2.2 STRUCTURAL AND SYSTEMS ENGINEERING

2.2.1 Building Structures Design Description

Table 2.2-2 Definition of Wall Thicknesses for Seismic Category I Structures: Containment Internal Structure, Reactor Building, and Power Source Building (Sheet 2 of 17)

Figure 2.2-1 US-APWR Building Configuration (Plan View)

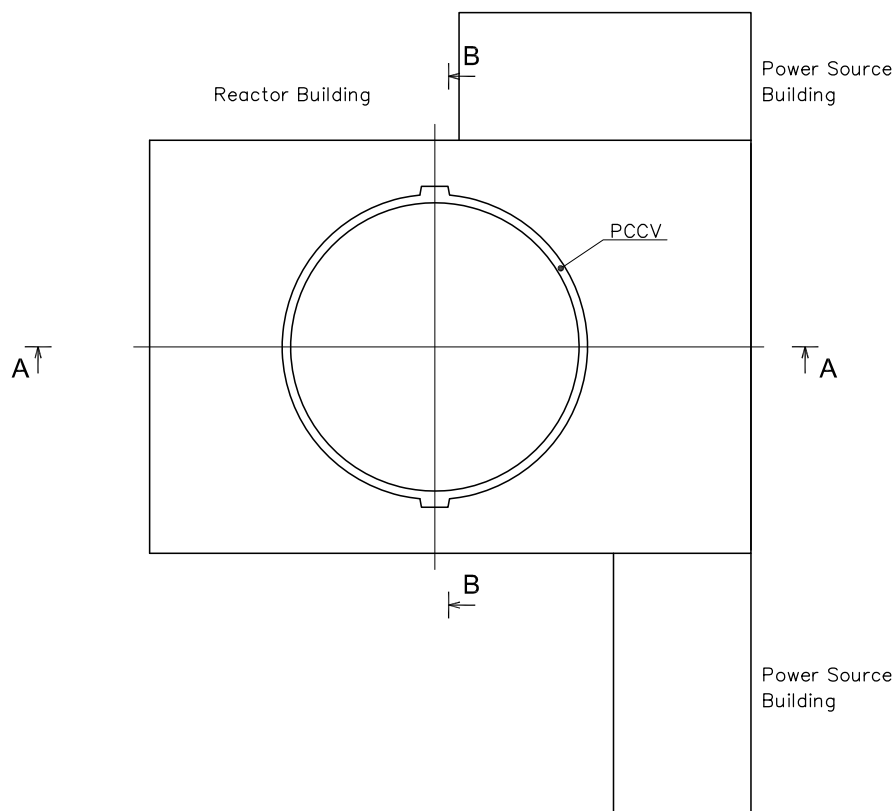
DCD_03.07.
02-35
MIC-03-T1-0
0066
DCD_14.03.
02-21

Figure 2.2-2 US-APWR Building Configuration (Section Views)

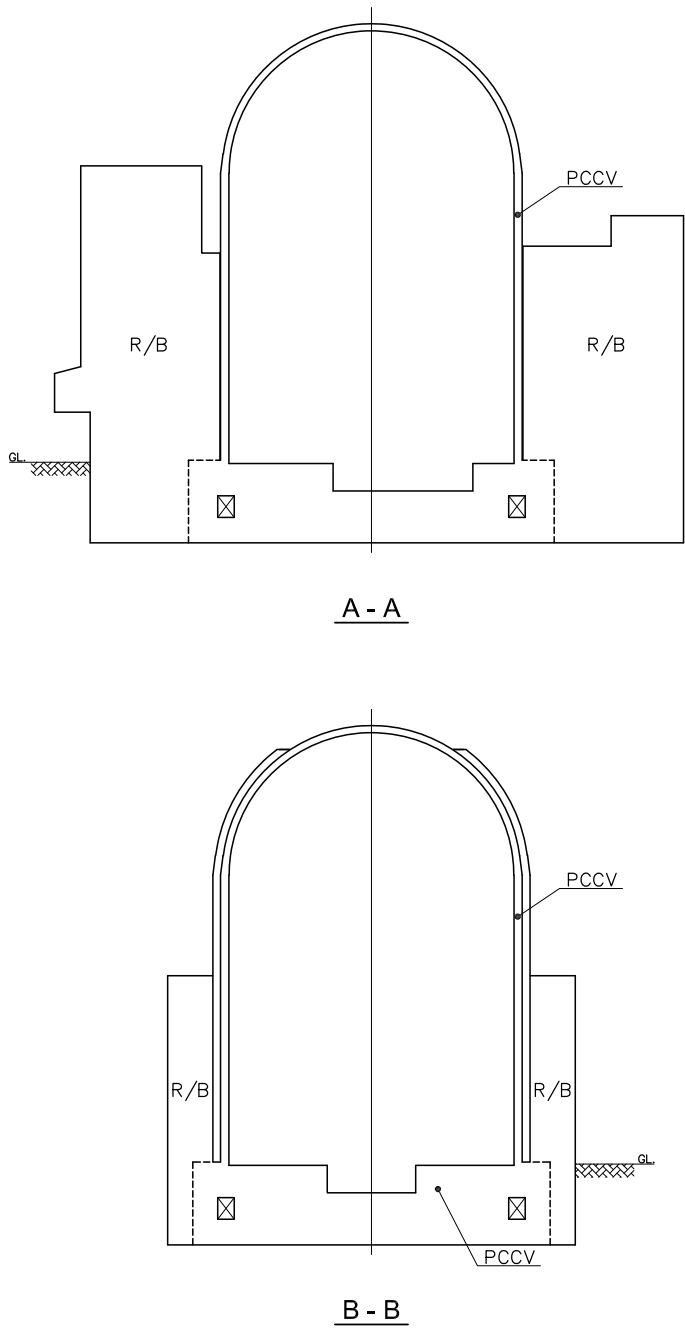
MIC-03-T1-0
0005
